# Conceptual Review Agenda

Schedule for 06/27/16 to 06/27/16

# 846 SE Frontage Rd Unlimited Indoor Recreation

CONCEPTUAL REVIEW: APPLICATION

2 Site Plan - Aerial Background  
1" = 40'-0"

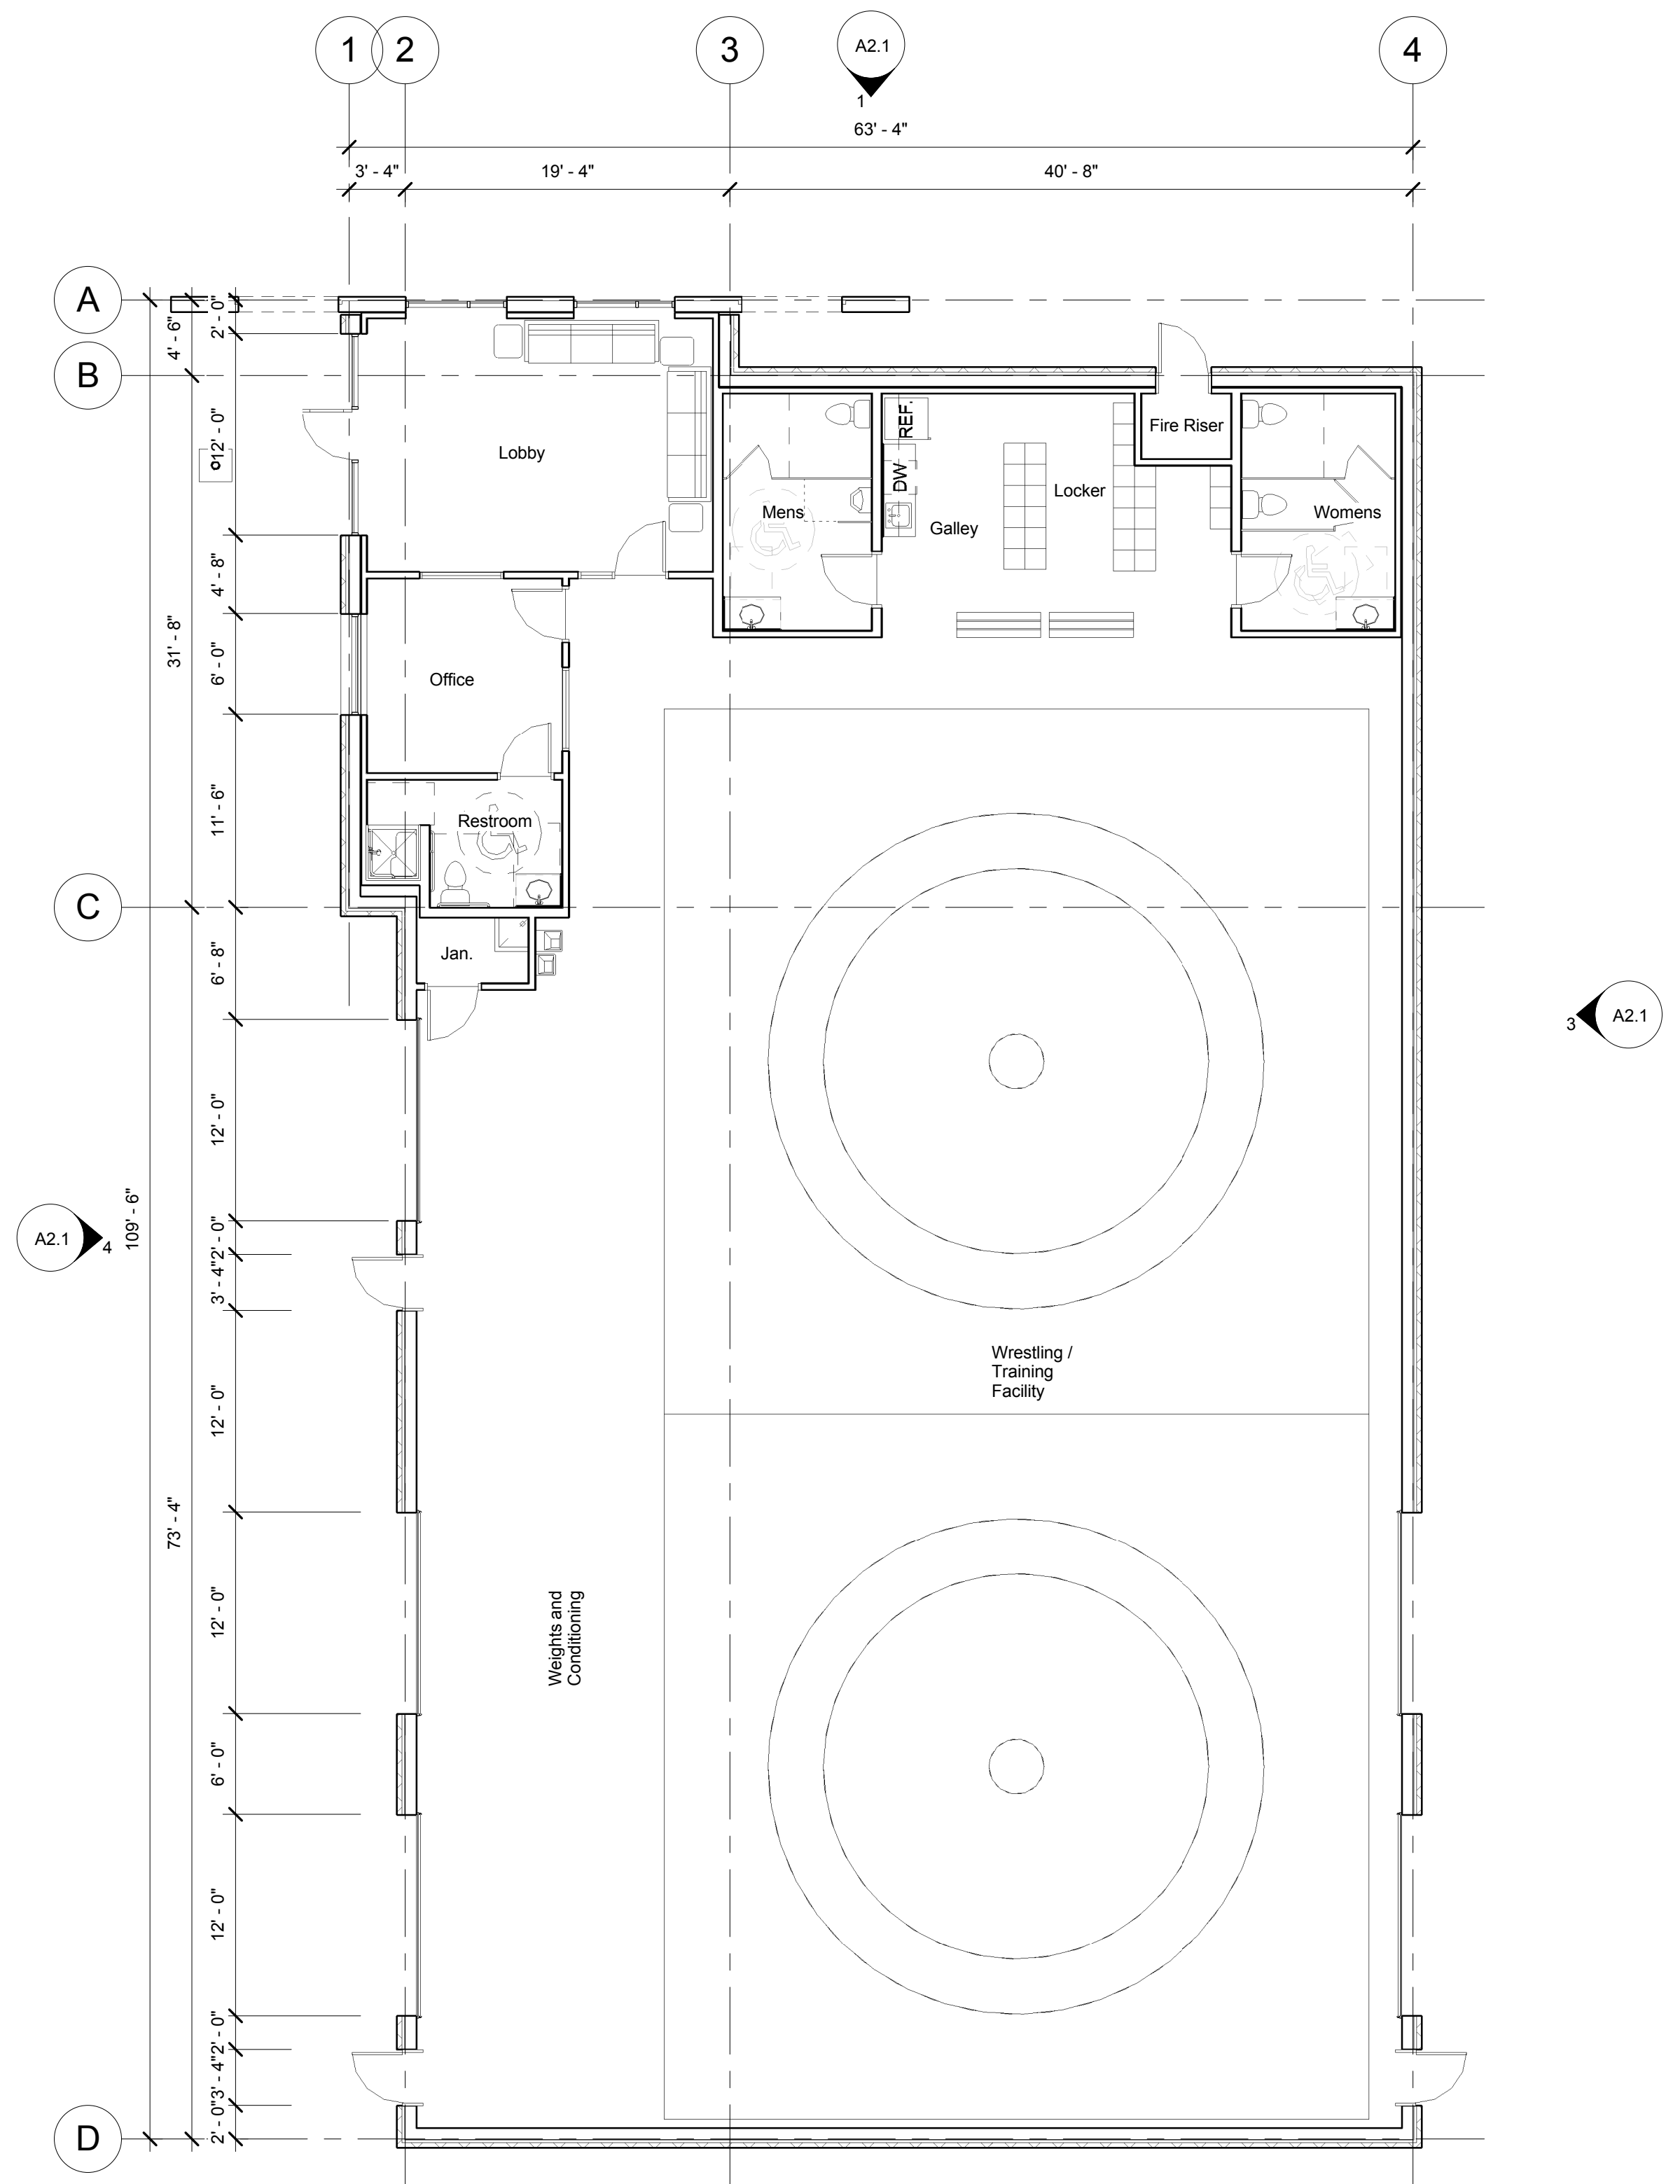
2. 2. The plans submitted for conceptual review show the proposed structure just touching the current regulatory flood fringe, but outside of the floodway. Please move the building slightly south to make sure it is located out of both the flood fringe and the floodway. Because the structure is located so close to the boundary, survey is required prior to pouring the foundation, to ensure that the structure is outside of the floodplain boundary. Elevation of the structure above the 100-year flood level is strongly recommended even if not required by code due to the close proximity to Boxelder Creek.

6. 6. The plans submitted for conceptual review show site improvements currently within the floodway as phase 2 that will occur after the LOMR is approved. At that time, some of the improvements (fence, parking, etc.) may still be located within the flood fringe and a floodplain use permit would be required prior to construction of those improvements.

All Commercial buildings are required to be within 300ft of the nearest Hydrant. It appears from the Site Plan provided that this criteria has not been met. Code language provided below

4. The area to the south of the site is rather naturalized along Boxelder Creek and many songbirds were seen and heard along the irrigation ditch during a recent site visit to the property. I see addition of a security fence on the conceptual plan and believe it would be a good amenity at the site and to serve screening purposes. Note Land Use Code 3.4.1(I) calling for project design and aesthetics to complement the visual context of the natural habitat. In this case, security fence color(s) could be chosen to be complementary to the naturalized area and designed to screen the naturalized area from vehicle and/or parking lot lights.

1. The parcel lies between two driveways but the site plan does not indicate the existence of an access easement across the two adjoining lots that would allow the subject parcel to gain access to the S.E. Frontage Road. The two dashed lines could be such an easement but there is no label. The Interchange Business Park was platted in the County. Please verify that such an access easement has been dedicated on the plat.

2. Both the subject site and the parcel to the south (858 S.E. Frontage Road) require an access easement along a segment of the shared side property line for parking and maneuvering. Please verify that such an easement has been dedicated. If not, then both property owners will need to dedicate one-half of the necessary easement.

3. The dashed lines on the site plan indicate that the aforementioned unspecified easement runs along the entire length of the shared westerly property line but the Training Yard encroaches into this easement. Due to this encroachment, it is not clear how vehicles would gain access to the rear of the building into the area designated as "Parking Overflow." Consequently, the extent of the Training Yard may need to be reduced.

4. The same comment applies along the easterly property line. It appears that the entire length is encumbered by some type of easement, as indicated by the dashed lines, yet the site plan indicates that this area is used for landscaping, access to overhead doors and an area that is not colored in.

8. Staff is concerned that as proposed, the site plan leaves little opportunity for landscaping. The streetscape landscaping may have to be enhanced and pockets of landscaping may have to be carved out as mitigation.

9. Given the proposed building placement, the P.D.P. would need a Modification of Standard to the Build-to Line per Section 3.5.3(C)(2). The project represents an infill condition within a business park that was mostly developed in Larimer County. Such a Modification could be supported subject to providing a connecting walkway between the public sidewalk and the building entry. This walkway should be enhanced with a crosswalk and landscaping where feasible. In addition, a Modification request would call attention to the Contextual Setback that has been established within the business park which may be considered per Section 3.8.19(B).

10. Please provide details of the proposed Security Fence.
11. On the left side of the east elevation, the site plan indicates what appears to be additional vehicle access to the overhead doors. The floor plan does not indicate a specific purpose in this area of the building. Please label and indicate the purpose of needing vehicular access in this location.

1 North Elevation  
1/8" = 1'-0"

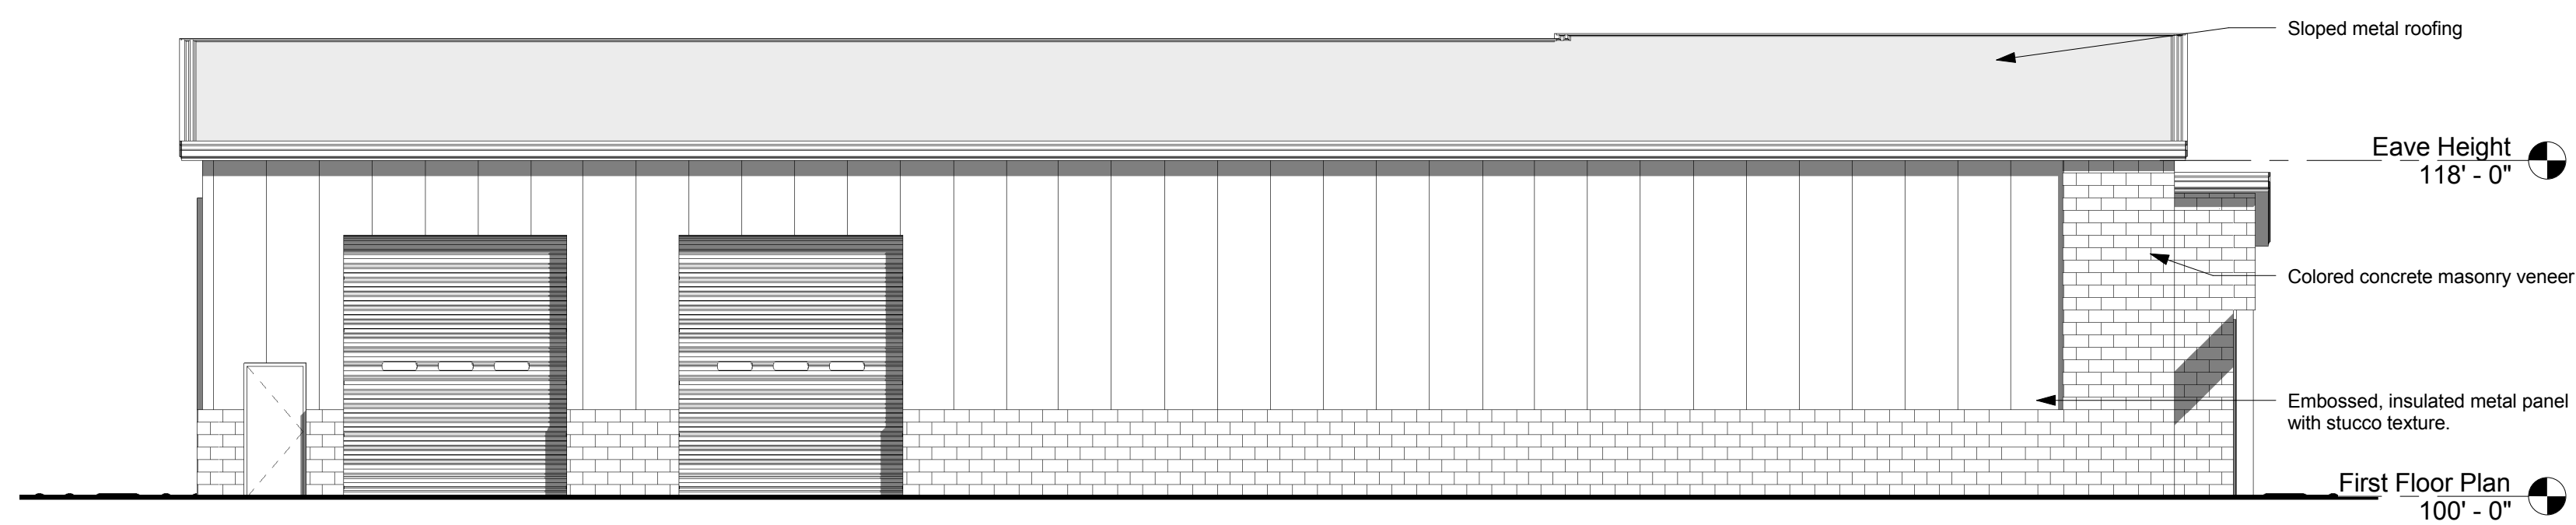
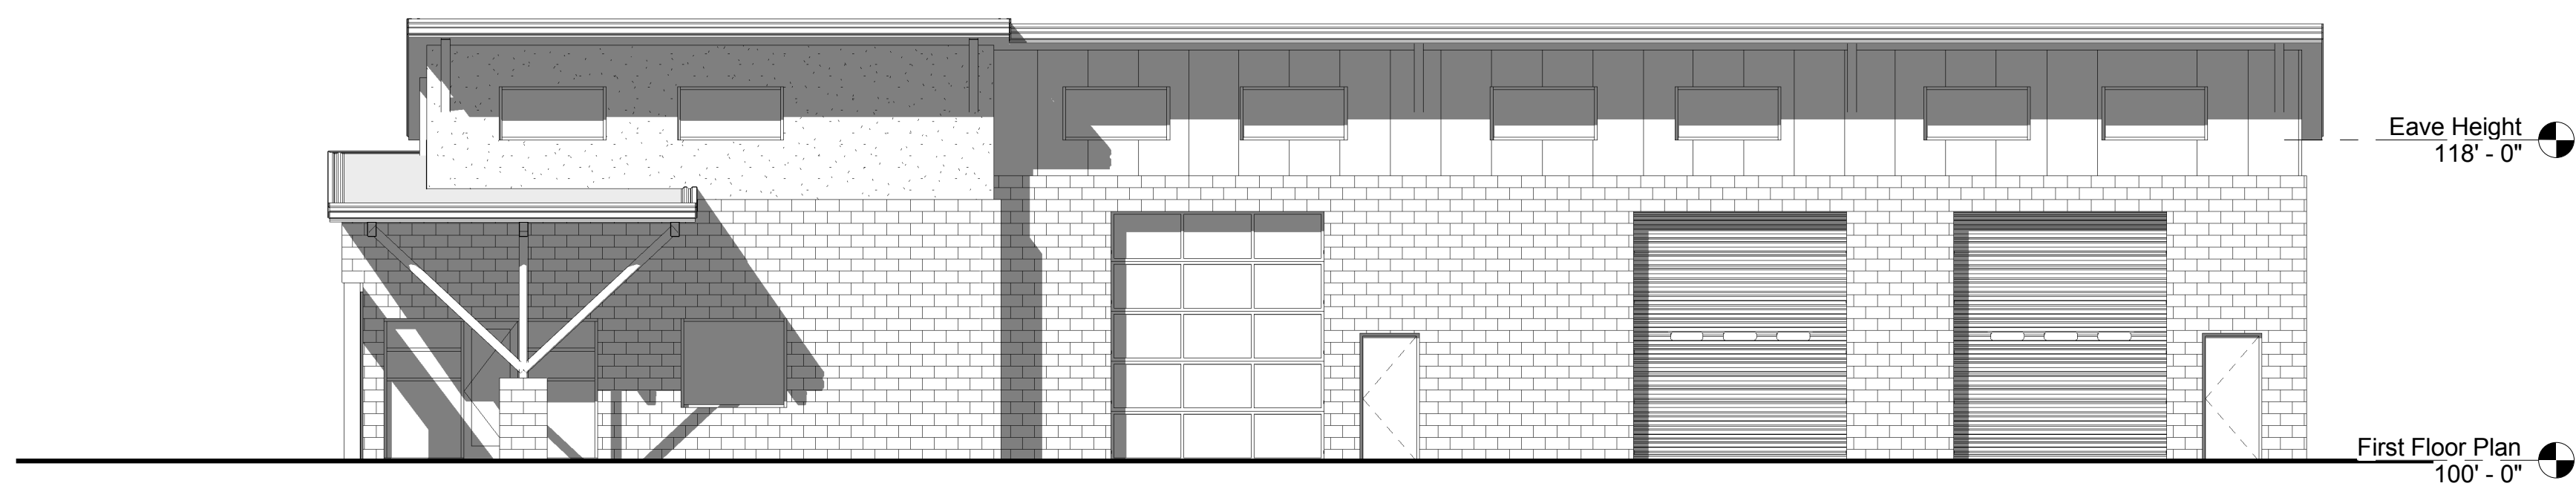
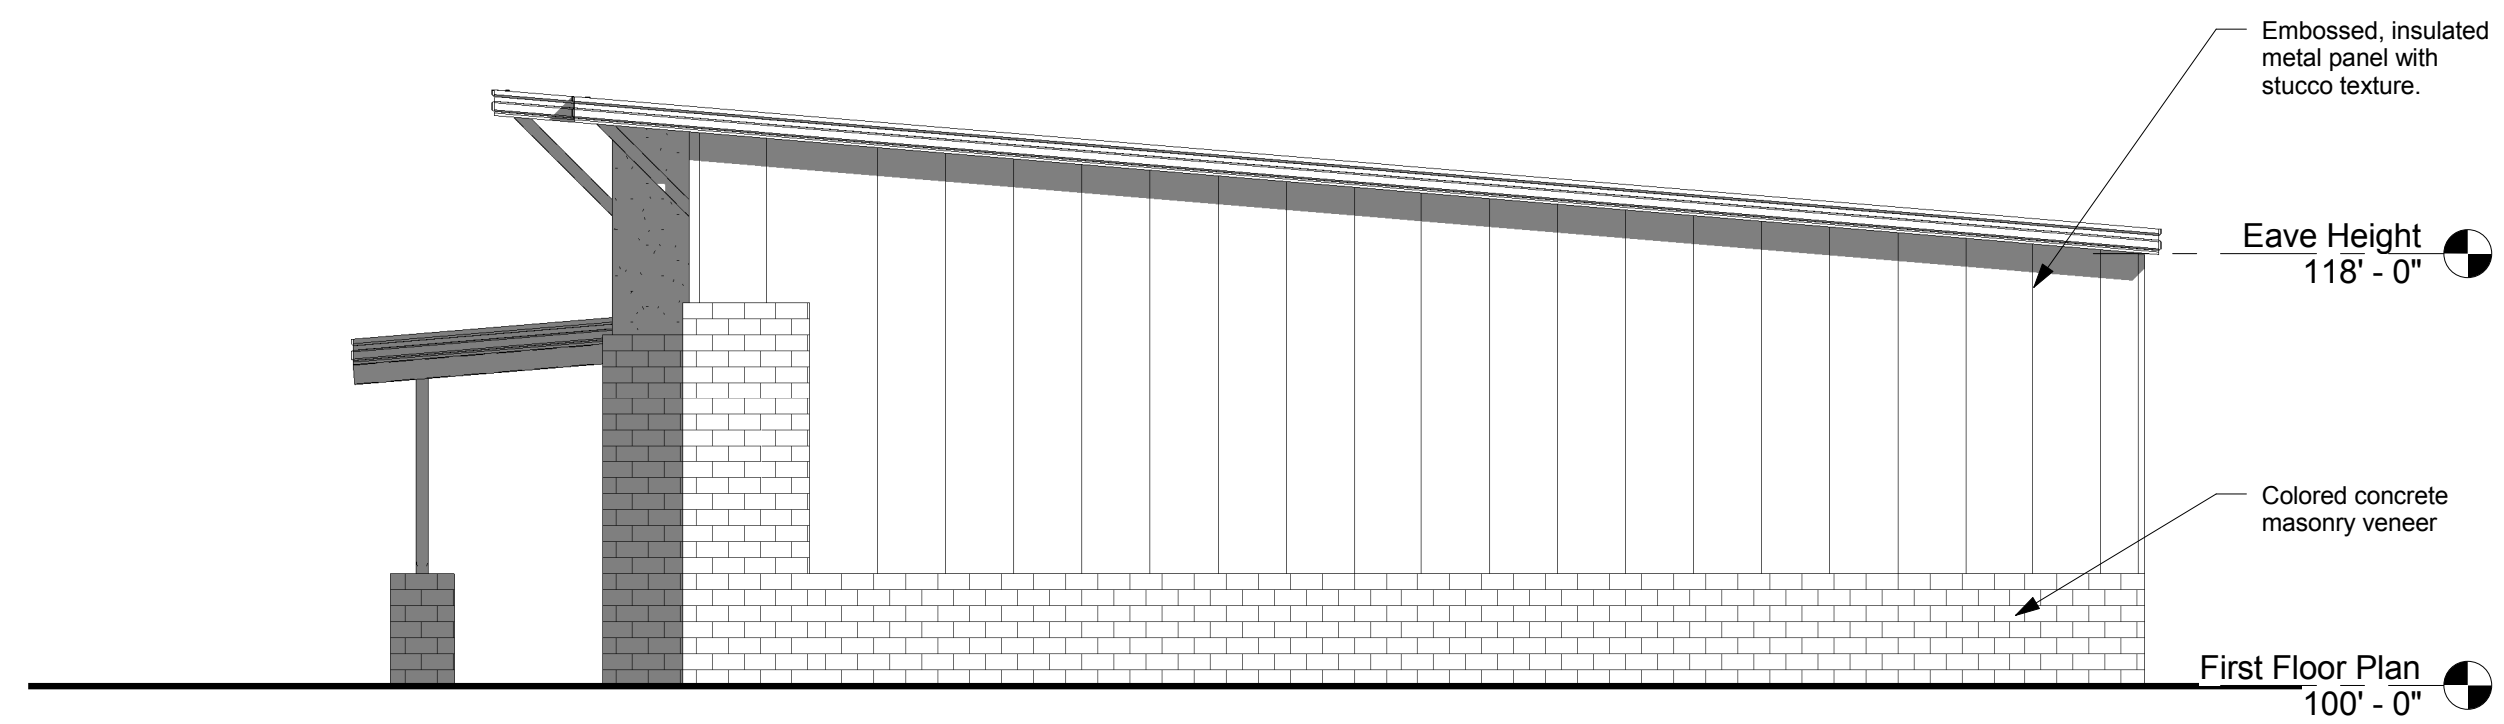
6. Along the north elevation, please provide a weather protection canopy over the exit door.
7. The exterior materials indicate “Colored Concrete Masonry Veneer.” Please note that smooth-face block is not allowed and that any block selected must be heavily textured. Staff recommends that as this project moves forward, a sample material board be provided including color chips for the overhead doors.

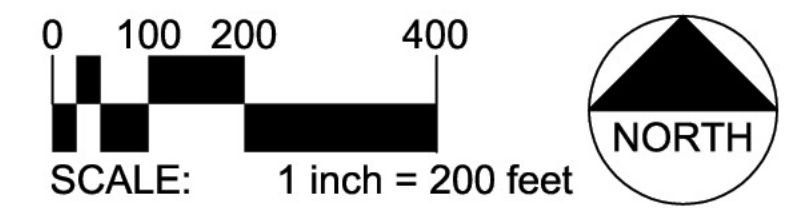
From the provided Site Plan it appears that some streets may be out of compliance on maximum length allowed without a secondary access. Future street connections usually cannot be allowed in these calculations. Any house past 660ft to the north west from the intersection at lot 147 will have to be sprinklered per the Fire Marshall 6-27-2016  
> FCLUC 3.6.2(B): Cul-de-sacs are permitted only if they do not exceed 660 feet in length and have a turnaround at the end with a minimum outside turning radius of 50 feet (100 foot diameter).

Per the Fire Marshall, 6-27-2016, the minimum requirements for two access points shall be 1)The completed Zephyr Drive on to Timberline 2)The proposed Fire Lane extension by lot 83 denoted on the provided Site Plan as Rosen Dr extension. This will be required to have access gates with appropriate emergency access locks and a maintenance plan for snow removal and weed control.

2. In the current conceptual plan it appears the project is attempting to be designed in a way that is sensitive to the current pond and wetlands on-site, although, some lots appear rather close to the edge of the existing pond. In the ECS document ensure clarification of extent of each natural feature on-site, including those associated with any and all irrigation ditches through delineation and estimated acreage. These delineations may affect the site layout as currently proposed. Additionally, in the next round of review, please address how the site design may alter water flows and/or recharge of the existing pond and wetlands.
